**CITY OF VANCOUVER
PLANNING & DEVELOPMENT SERVICES**

**DEVELOPMENT PERMIT STAFF COMMITTEE
MEETING
April 3, 2019**

**600 Robson St (COMPLETE APPLICATION)
DP-2018-01155 – DD**

(Source: Rendering produced by Perkins + Will, 2019)

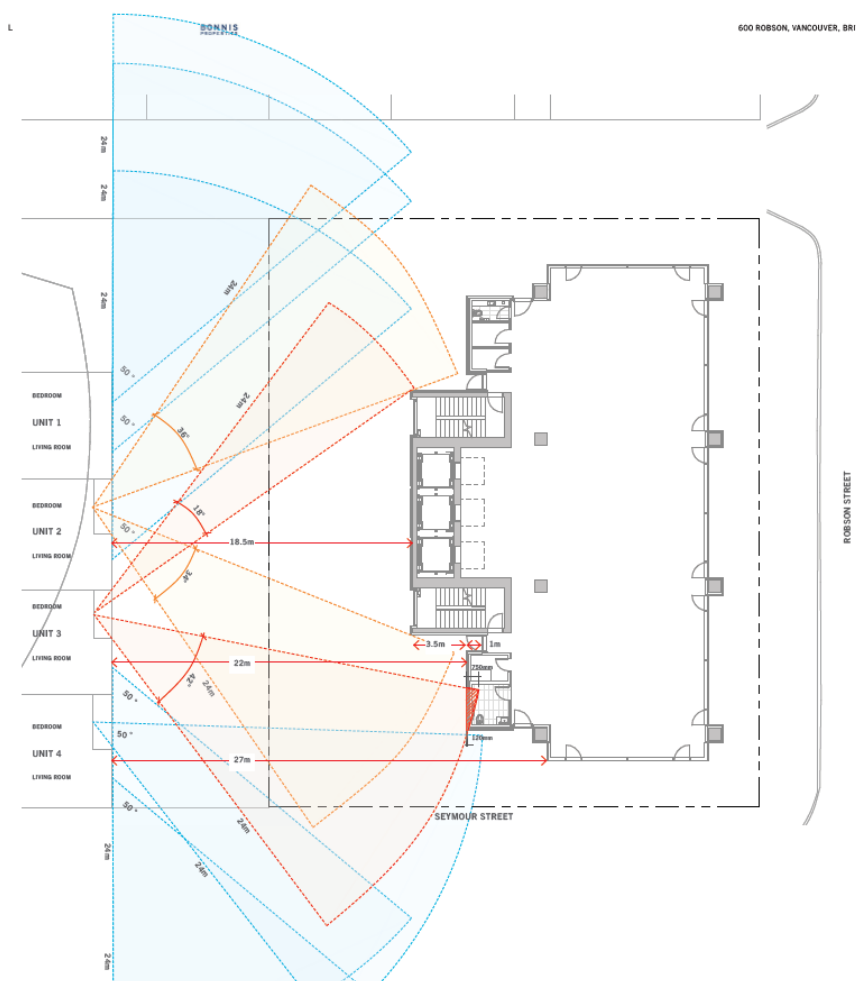
Basic maximum height is 91.2m (300 ft.). Proposed height is 214.57 ft. with the upper storey sloped to minimize shadowing in particular to the northwest corner of Robson and Granville St.

Staff recommends Conditions 1.1(i-vii) to improve the quality of the public plaza design. Improvements include revisions to the raised terrace to clearly distinguish as a public space, enhance safety and activation by minimizing blank exterior walls, contributing to pedestrian interest by enhancing screen design (existing party wall) until planting has established, strengthening entry sequence by enhancing pedestrian scale, development of soffit condition at double height outdoor spaces (levels 2 and 6), lighting and signage strategy and consideration to add public art per the renderings provided.
